Public Service Company of Colorado #1

May 10, 1976  
Fort St. Vrain  
Unit No. 1  
P-76104

Subject: Attachment A & B to  
Replace P-76034  
Transmittal

Information on Cable Non-Conformance

Figure 1

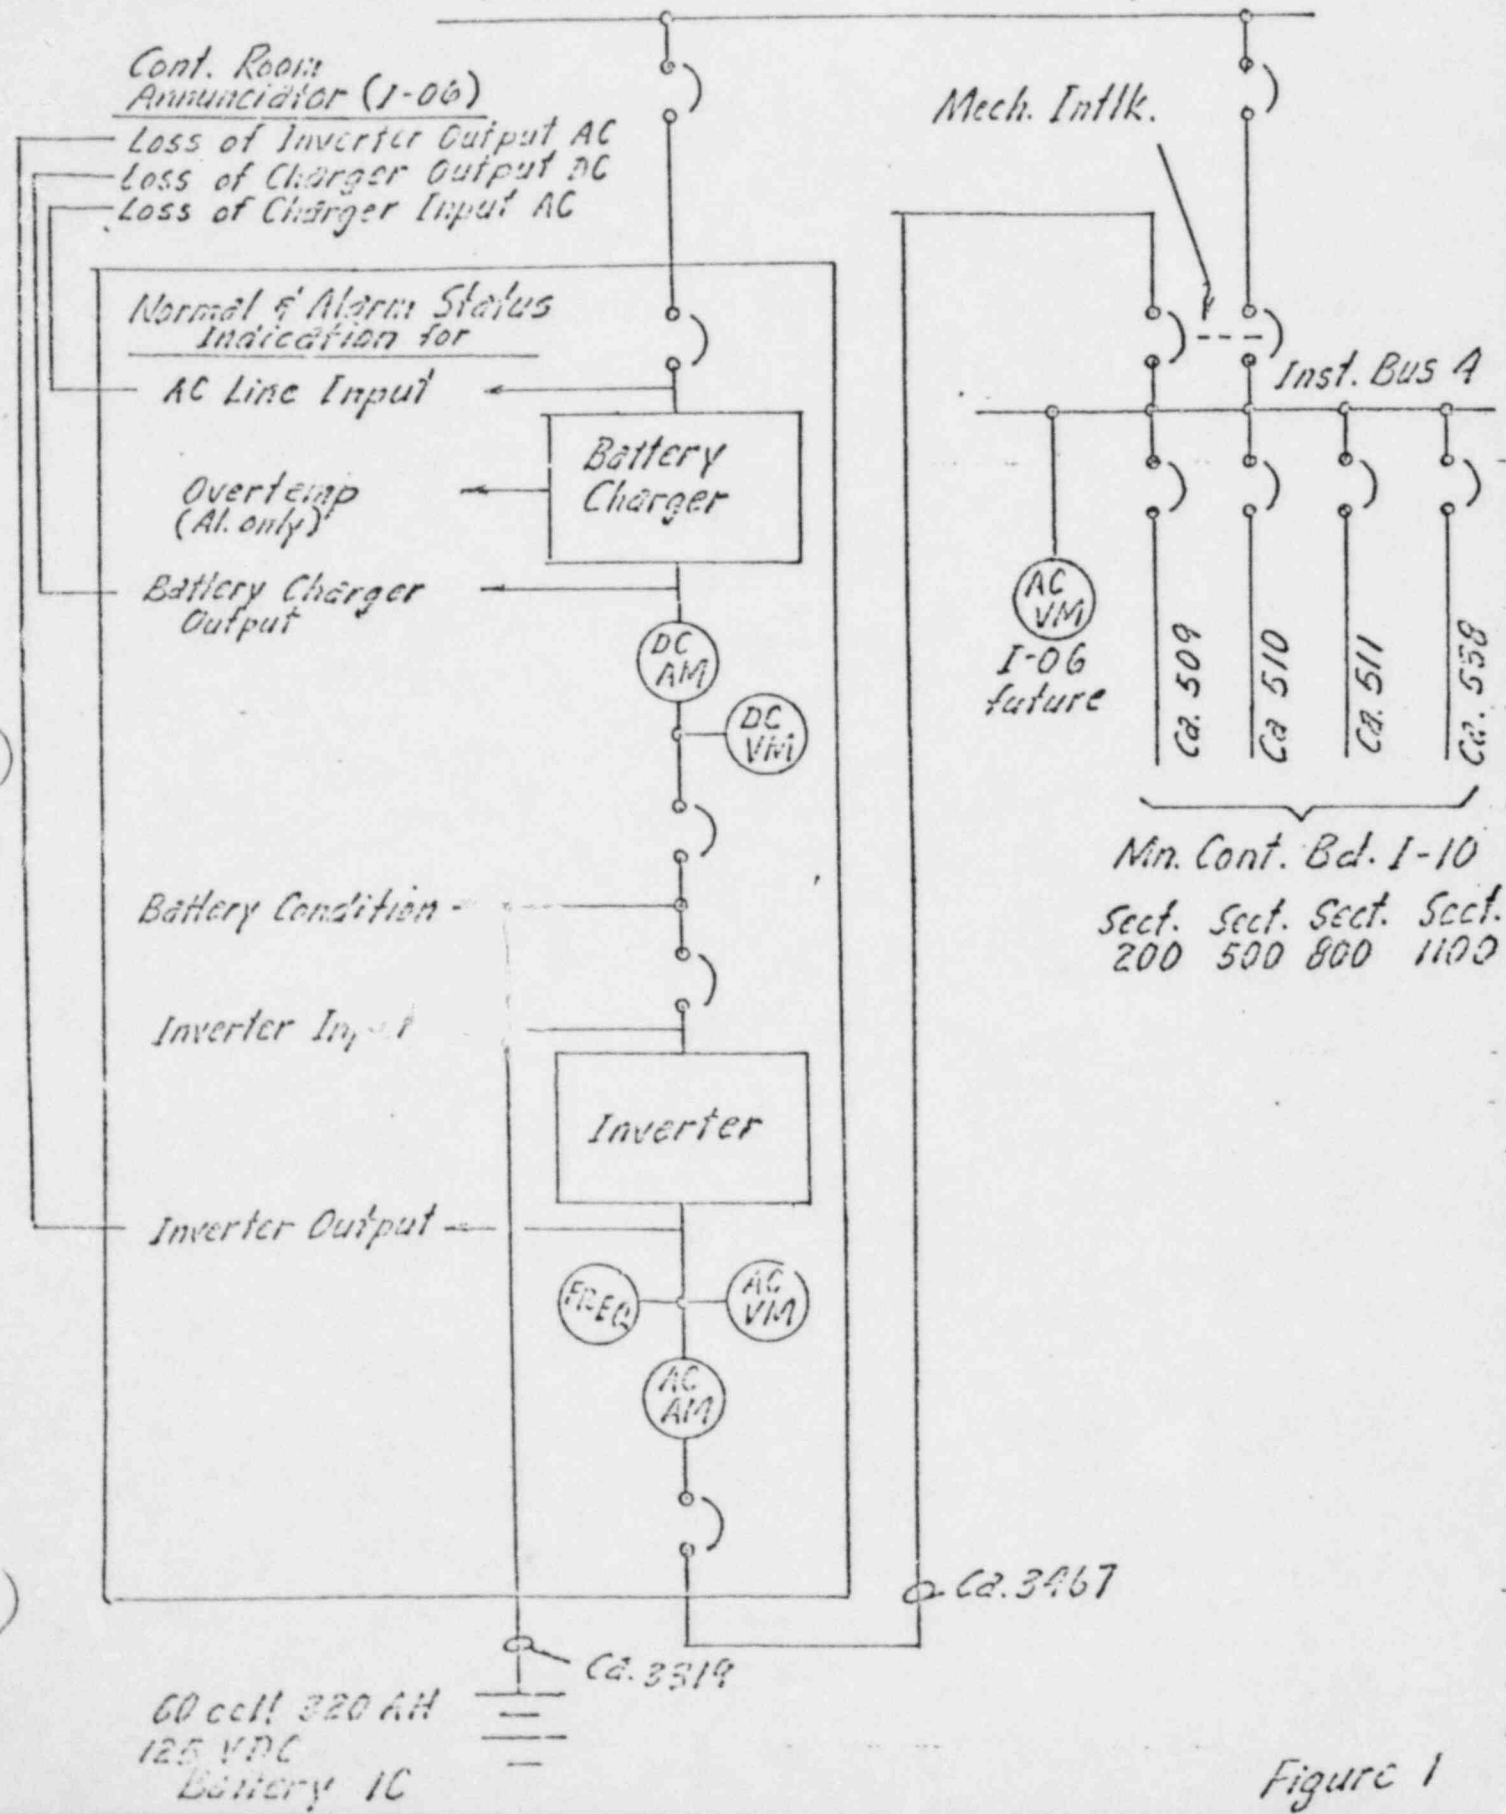
1. Paragraph 3, Discussion, Page 12 - Replace existing Discussion paragraph with the following:

A Class 1E battery charger, Class 1E inverter, and Class 1E battery have been installed which will provide a separate Class 1E power source for the plant protective system equipment presently being supplied by interruptible 120V AC, Bus 3. A separate seismic Class I Battery Room has been provided to house the new Class 1E battery.

The new non-interruptible 120V AC bus has been designated:

120V AC, Bus 4

Equipment installed:

Battery 1C

Battery Charger - Inverter 1C

Non-Interruptible Bus 4

New essential cables installed:

3319, 3467

Cables 509, 510, 511 and 538 associated with the PPS are being reconnected from 120V Instrument Bus 3 to 120V Instrument Bus 4.

Figure 1, attached, indicates the electrical configuration of this new equipment.
